**PD Modification Application: PRS 24-0133**

**BOCC Land Use Meeting Date: January 9, 2024**

**Applicant:** NexMetro Bay Farms, LP

**APPLICATION NUMBER: PRS 24-0133**

**8.1 Approved Site Plan (Full)**

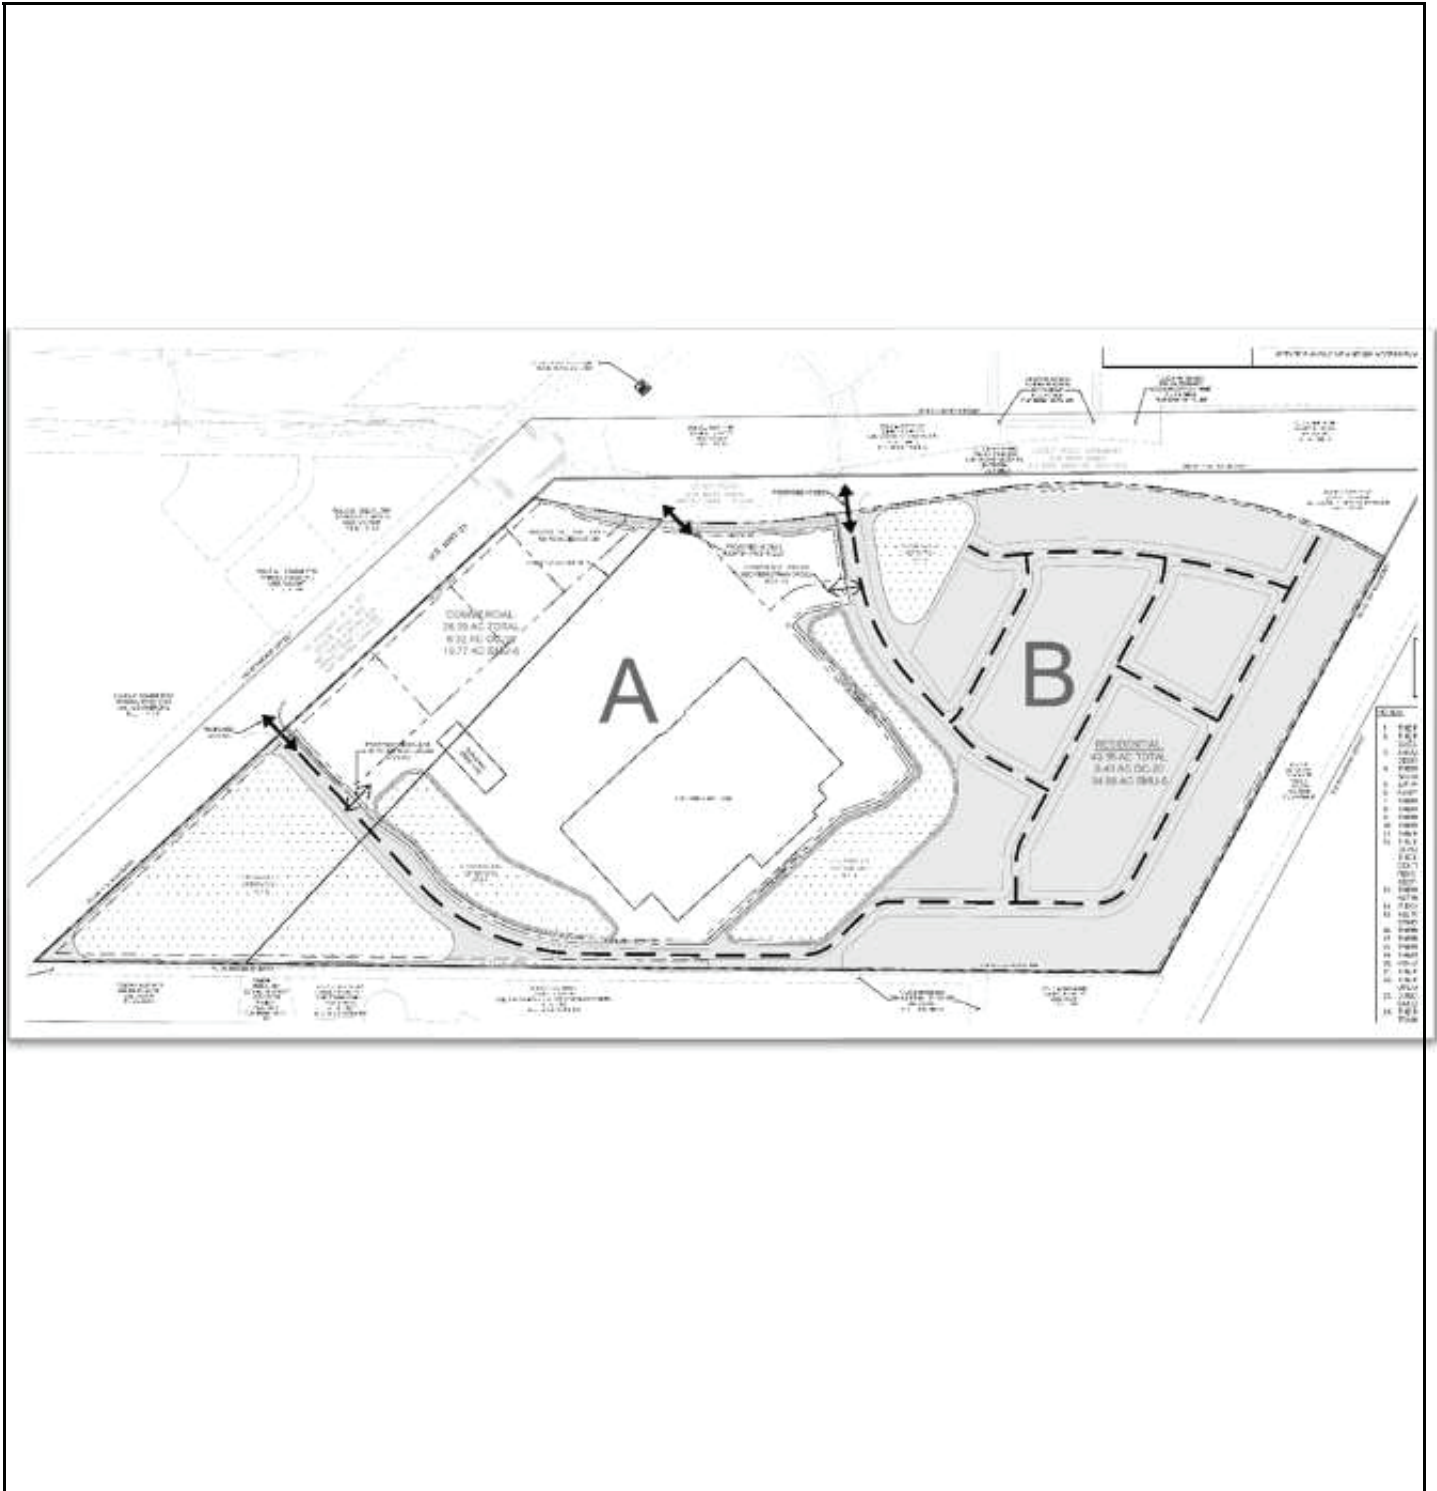
| Existing Approval(s):   | Proposed Modification(s):  |
|---|--|
| The development plan shows five outparcels.   | The general development plan is being changed to show six outparcels.  |
| Single storm water pond configuration (pond located near SW boundary of Pocket A)   | The storm water pond located near the southwest boundary of development Pocket A is being changed to two ponds to allow for an additional internal access point.   |
